BLACK OLIVE VILLAGE

FINAL ENVIRONMENTAL IMPACT REPORT

State Clearinghouse No. 2017072065

AUGUST 2018

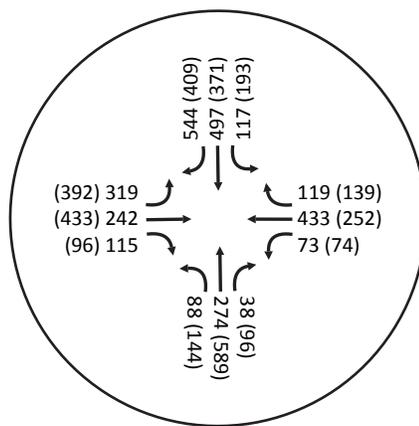
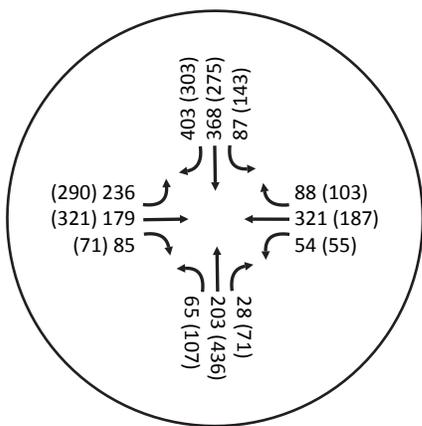
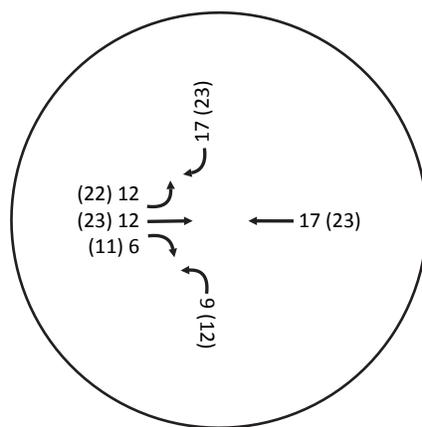
The traffic study should depict potential impacts at the intersection of SR 191 and Pearson Road. There will likely be a change in through movements turning left towards the new grocery location, increasing conflicts at these intersections.

1. SR 191/Pearson Road intersection should have been considered in the impact analysis. Please provide the rationale on this matter. According to page 19 of the TIR, trip distribution shows that 55% of the project generated traffic will use Pearson and Elliott Road. Please perform analysis on SR 191/Pearson Road and re-submit.
2. Figure 3 (Baseline AM Peak Traffic Volumes) and Figure 5 (2040 Baseline AM Peak Traffic Volumes) show same volume counts. Please correct volume in figure 5 and all associated analysis done using this future baseline volume.

As requested by Caltrans staff, an intersection operations analysis was prepared for the State Route 191 (Clark Road) and Pearson Road intersection. A memorandum documenting the results of the analysis is included in Appendix A to this Final EIR. The results of the analysis show that there would be no significant impacts at the Clark Road/Pearson Road under existing plus baseline and cumulative plus project conditions.

The current configuration of the Pearson Road/Clark Road intersection is shown in attached **Figure 1**. The intersection is controlled by a traffic signal with protected left-turn phasing on all approaches. Traffic signal phasing and splits were observed in the field and found to be consistent with the current signal timing schemes provided by Caltrans for this evaluation. The south leg of the intersection (Clark Road) is part of SR 191, with the Caltrans facility terminating at Pearson Road. It is important to note that the outside (right-most) lane on the southbound approach is striped as a through/right-turn lane. However, the lane is 20 feet wide and clearly functions as two lanes, a through and separate right turn. For the purposes of this analysis, a separate right-turn lane was used in the computations and analysis.

New AM and PM peak hour traffic volumes were collected on an average mid-week day in April 2018 with local schools in regular session. The existing peak hour intersection traffic volumes are shown in attached **Figure 1**.
